PROJECT TITLE HAVILAND FIELDS

ISSUE #	DATE	DESCRIPTION
1	2024-02-09	SITE PLAN REVIEW

LANDSCAPE NOTES / GRAPHIC LEGEND

L002

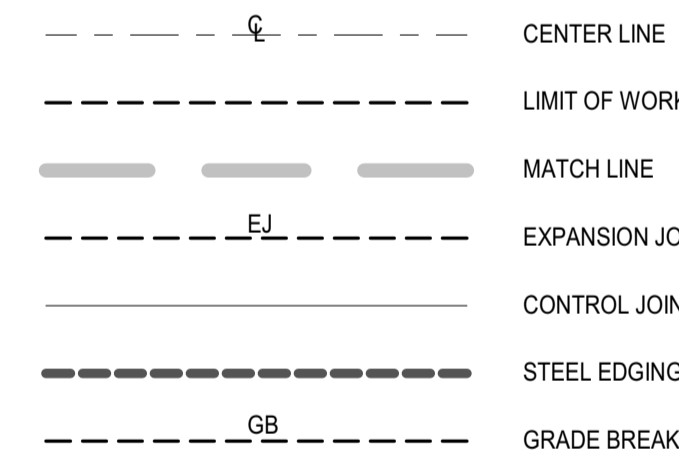
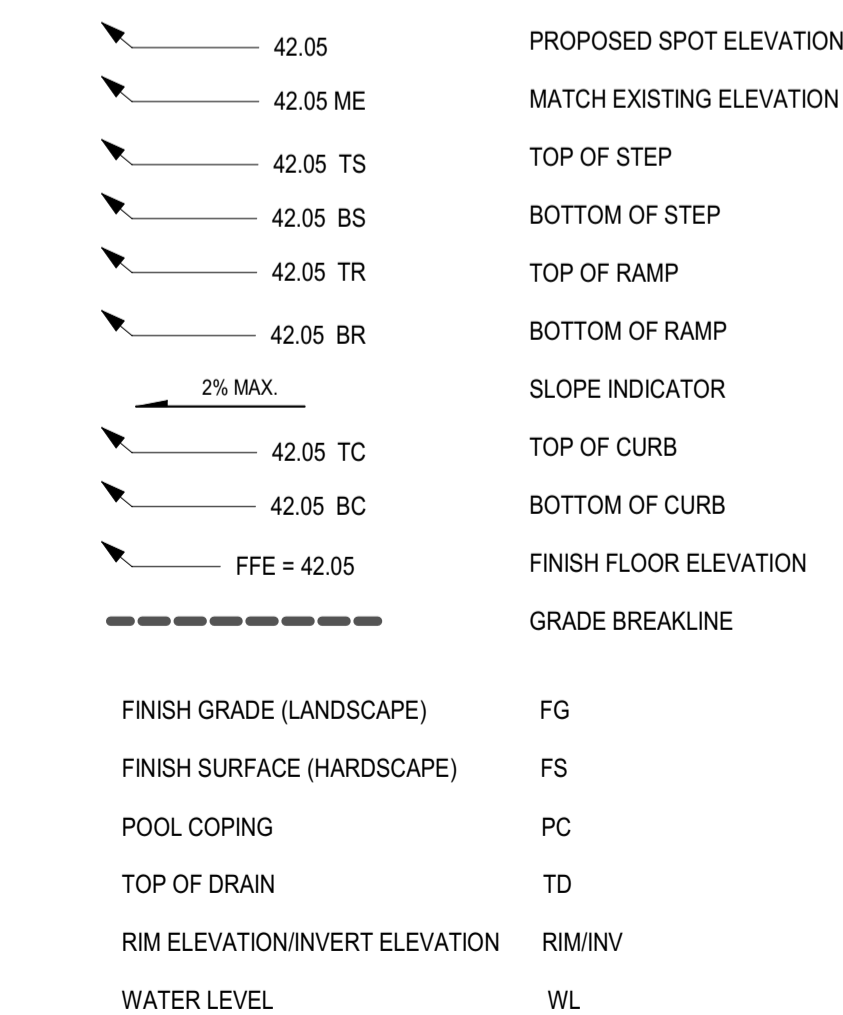
The City's Development Agreement requires a 2-year maintenance guaranty from the date of approval of landscape installation by the city.

The irrigation shall include not only a rain sensor but also some form of water efficient technology, such as a smart controller, soil moisture sensor(s), etc.

Will these numbers be filled in?

All disturbed areas not otherwise improved with impervious surfacing shall receive four (4) inches of topsoil with not more than 35% sand content.

L003

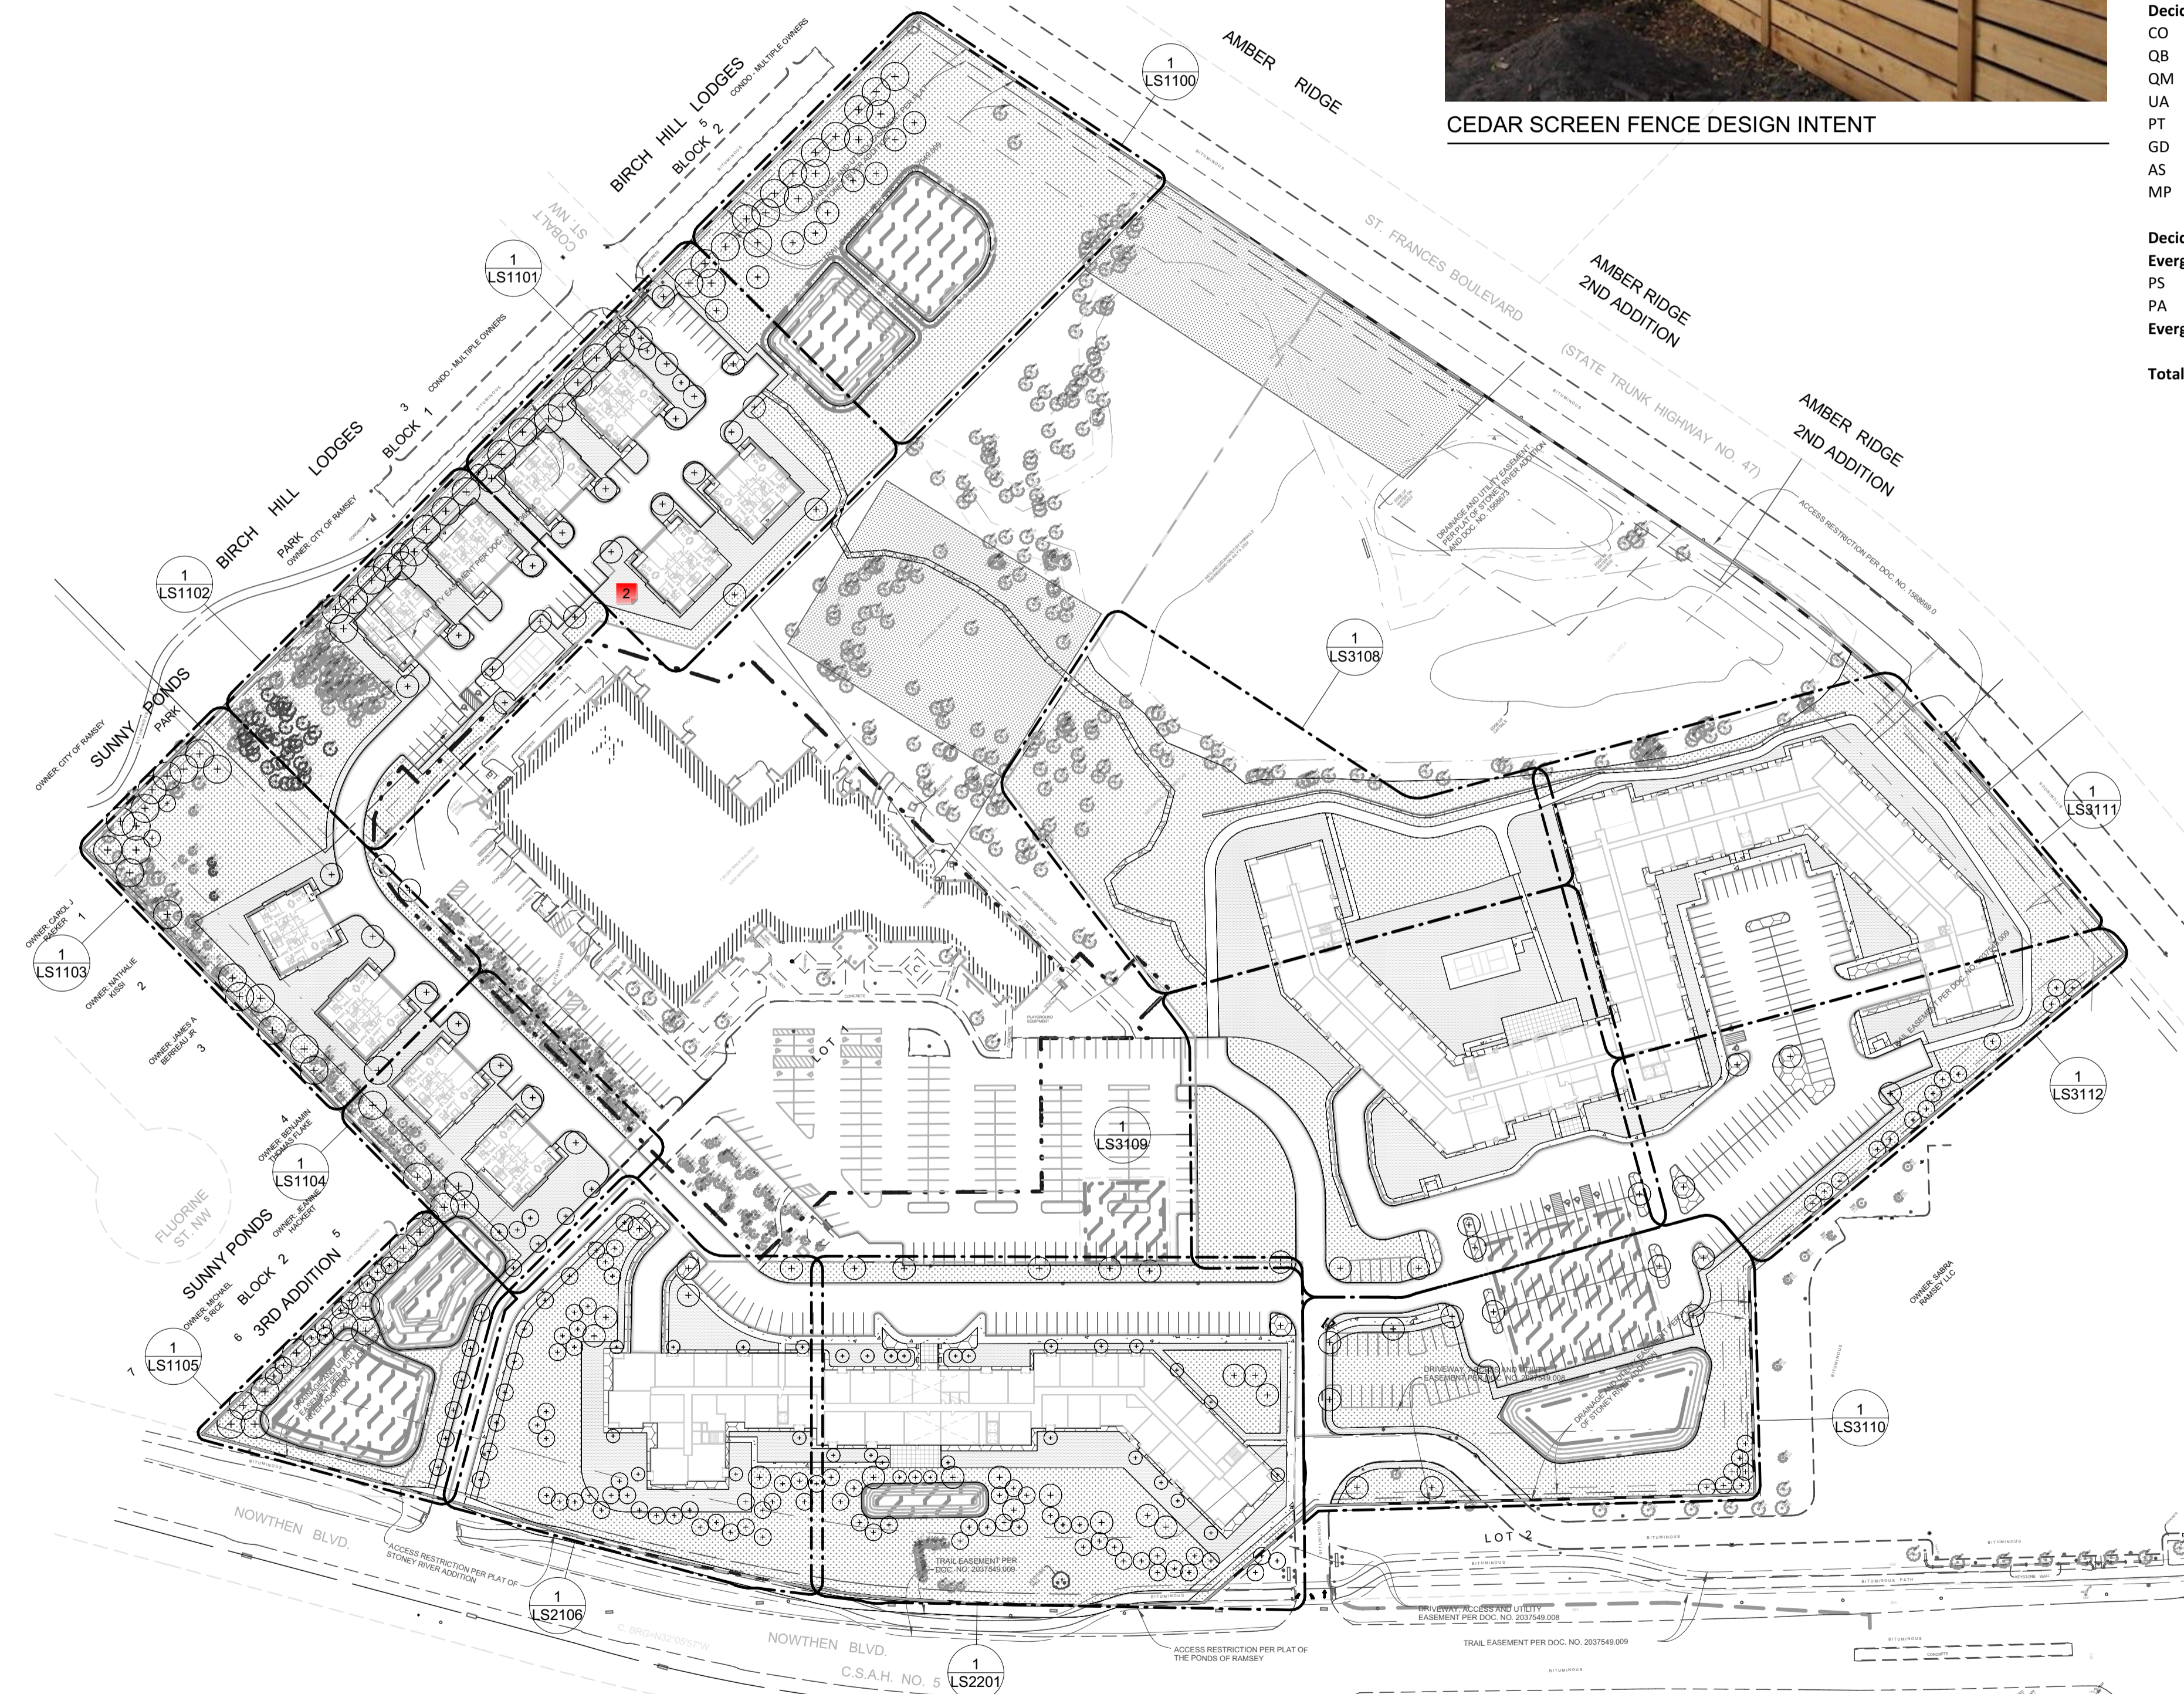
This symbol doesn't appear in the plan set.

What does this symbol represent? Add it to the legend please.

LS1100

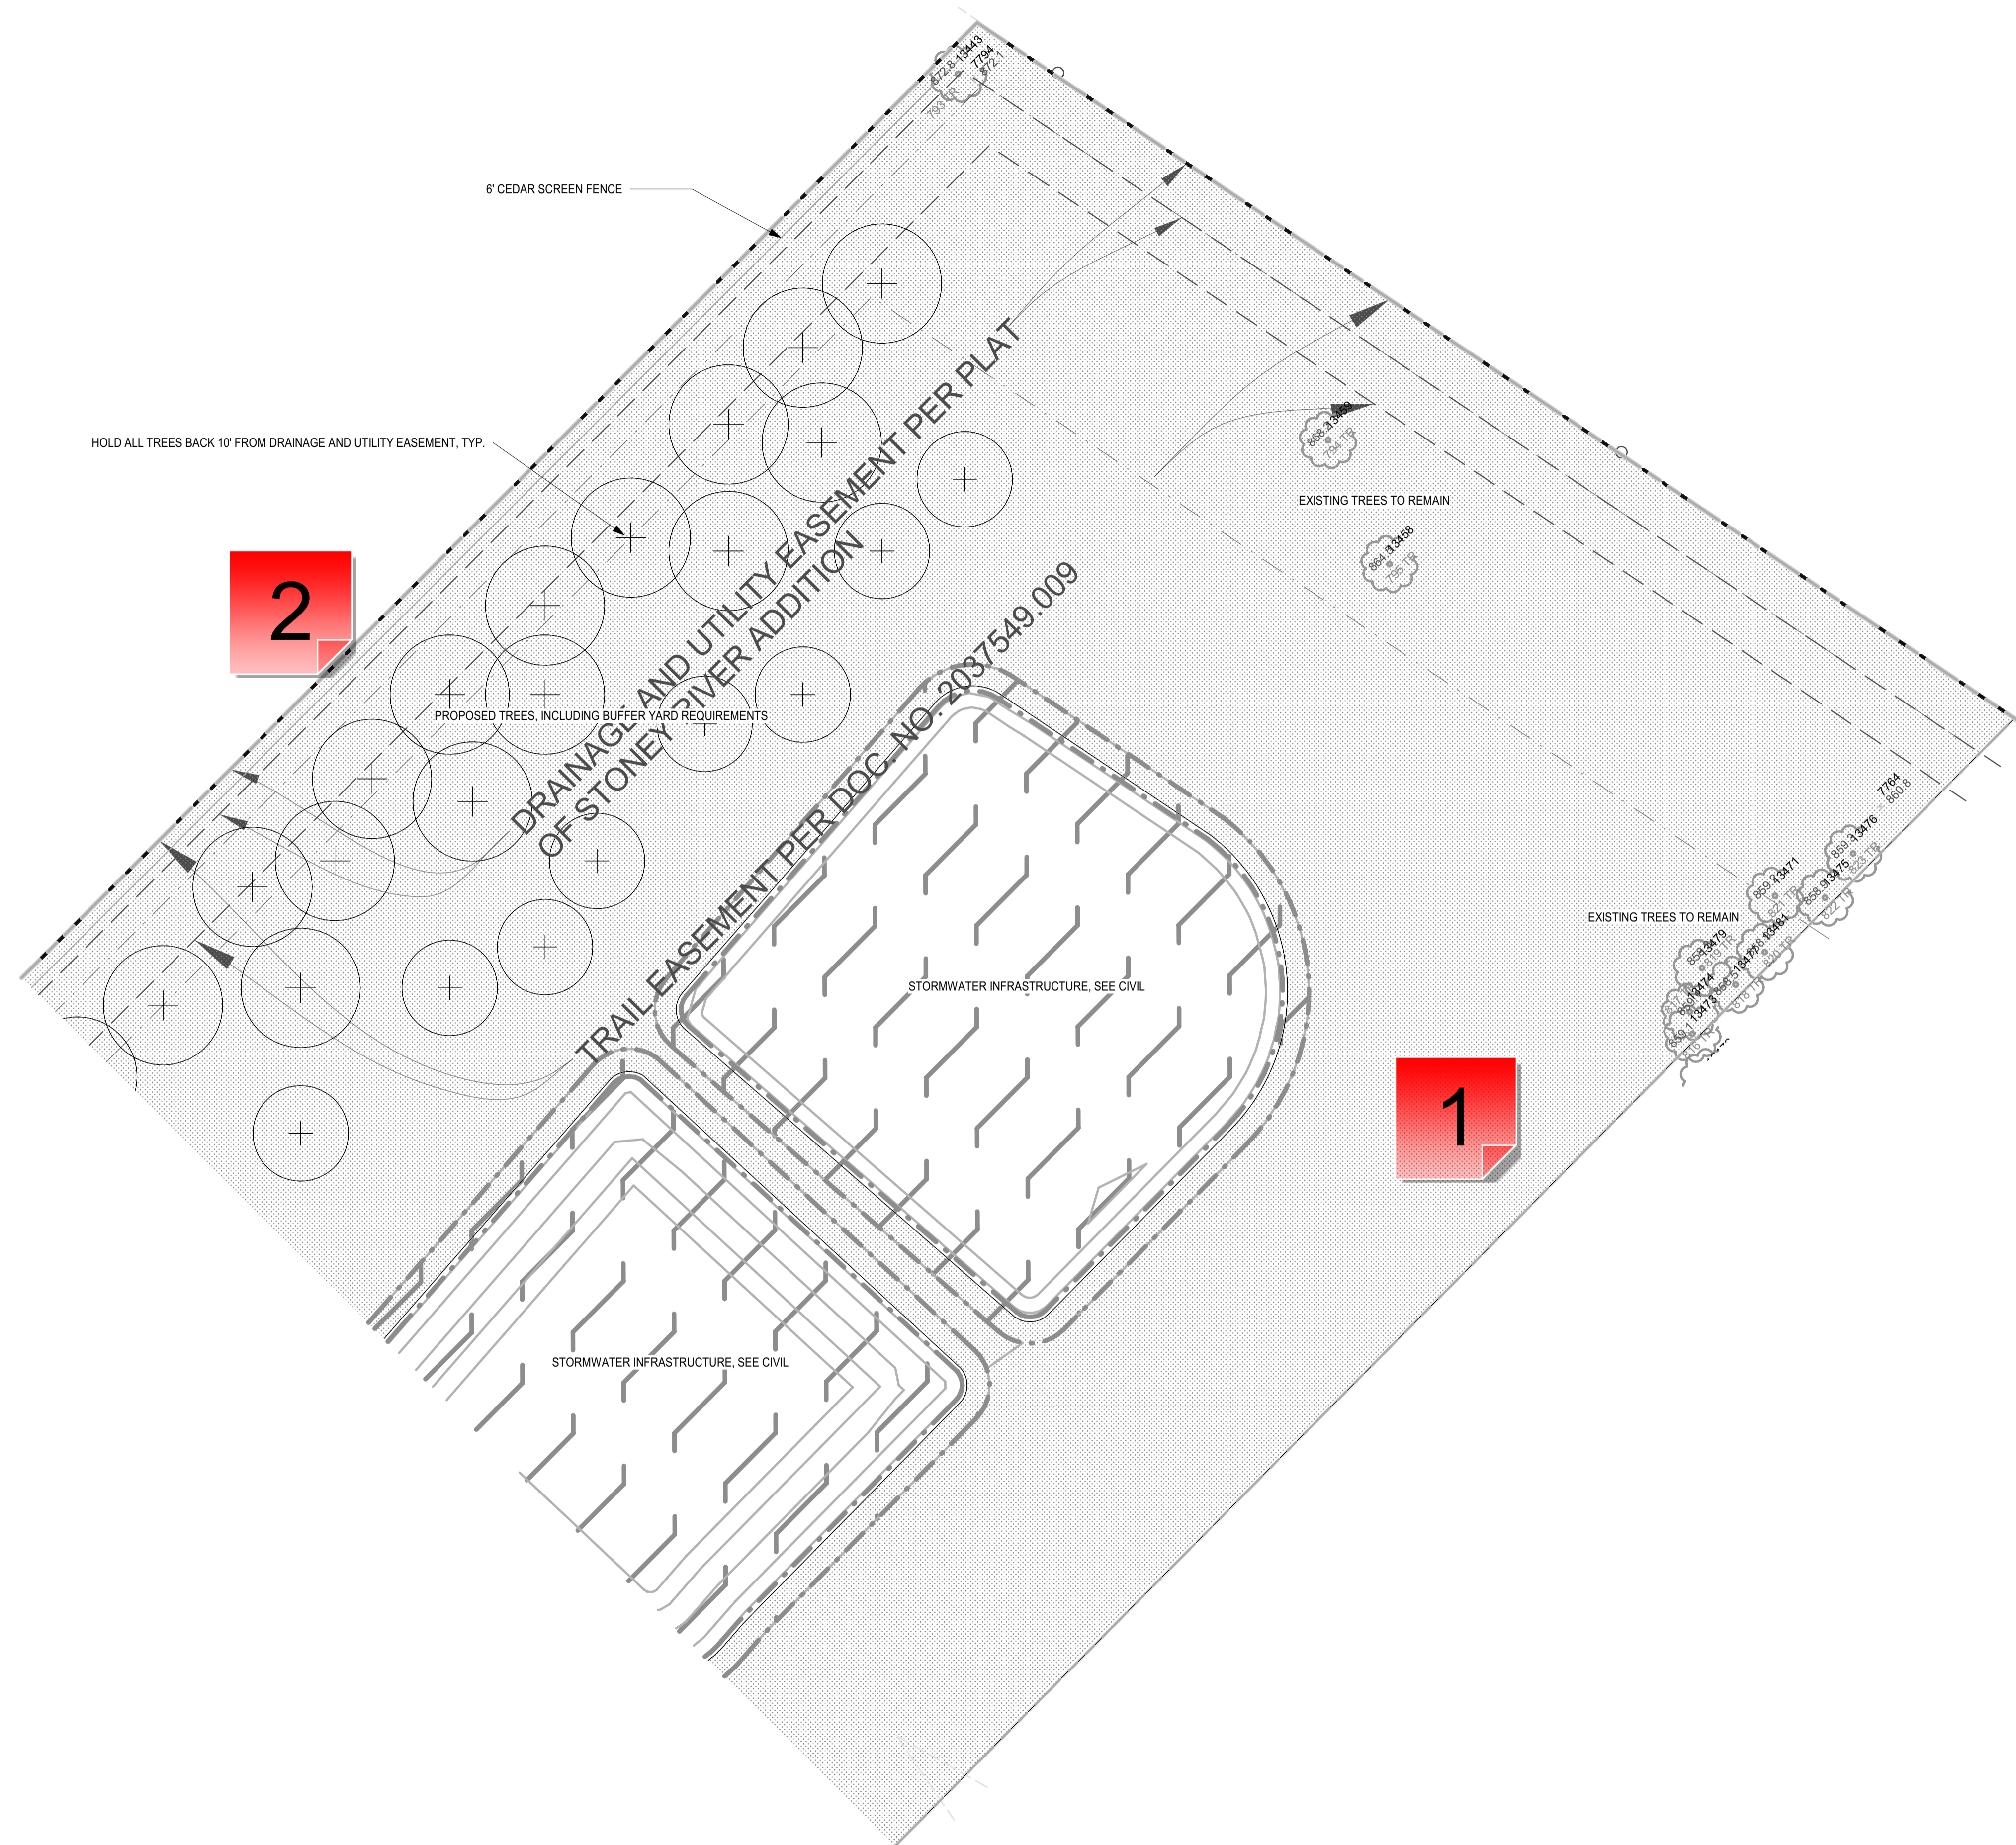
Is this sod or the dry mesic prairie mix? Add this to the legend so it is clear what it represents. If it is the prairie mix, please provide a management plan so that the property management will have a full understanding of what maintenance will be needed and when.

What species are all these trees? Please add symbols that correlate with the Proposed Plant Schedule.
